Access Compliance Report Public Rights-of-Way (Curb Ramps)

Intersection ID: 18778 Main Street: E_INDEPENDENCE_BV Cross Street: E_W_T_HARRIS_BV Location: W

ADA ID: 7EFEF356F6A1 Ramp Type: IslandPerp Initial Pass/Fail: Fail Overall Compliance: No Severity Score: 1.25

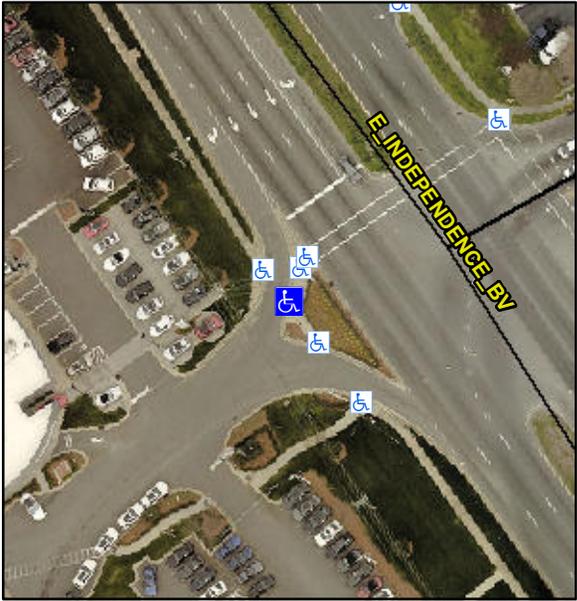
PROW/ADA:
Not Found, R304.5.3

Compliance	Description	Data	Compliance	Description	Data
N/A	Ramp Length (in)	88.0	Yes	Ramp Slope (%)	5.5
Yes	Ramp Width (in)	48.0	No	Ramp XSlope (%)	4.0
N/A	Flare Type LT	N/A	N/A	Flare Type RT	N/A
N/A	Flare Slope LT (%)	N/A	N/A	Flare Slope RT (%)	N/A
N/A	Flare Traversable LT?	N/A	N/A	Flare Traversable RT?	N/A
N/A	Landing Length (in)	N/A	N/A	DWS Provided?	N/A
N/A	Landing Width (in)	N/A	N/A	DWS Contrast?	N/A
N/A	Landing Slope (%)	N/A	N/A	DWS Length (in)	N/A
N/A	Landing X Slope (%)	N/A	N/A	DWS Full Width?	N/A
N/A	Landing Curb? (Y/N)	N/A	N/A	DWS Offset (in)	N/A
N/A	Shared Landing?	N/A			
N/A	Gutter Ponding?	N/A	N/A	Gutter Slope (%)	N/A
N/A	Gutter Lip Ht (in)	N/A	N/A	Gutter X Slope (%)	N/A
N/A	Painted X Walk1?	No	N/A	Painted X Walk2?	N/A
	X Walk 1 Direction	To NW		X Walk 2 Direction	N/A
N/A	X Walk 1 Width (in)	N/A	N/A	X Walk 2 Width (in)	N/A
	X Walk 1 Slope (%)	2.7		X Walk 2 Slope (%)	N/A
	X Walk 1 X Slope (%)	1.6		X Walk 2 X Slope (%)	N/A

Possible Solutions:
Remove & Replace Entire Ramp.
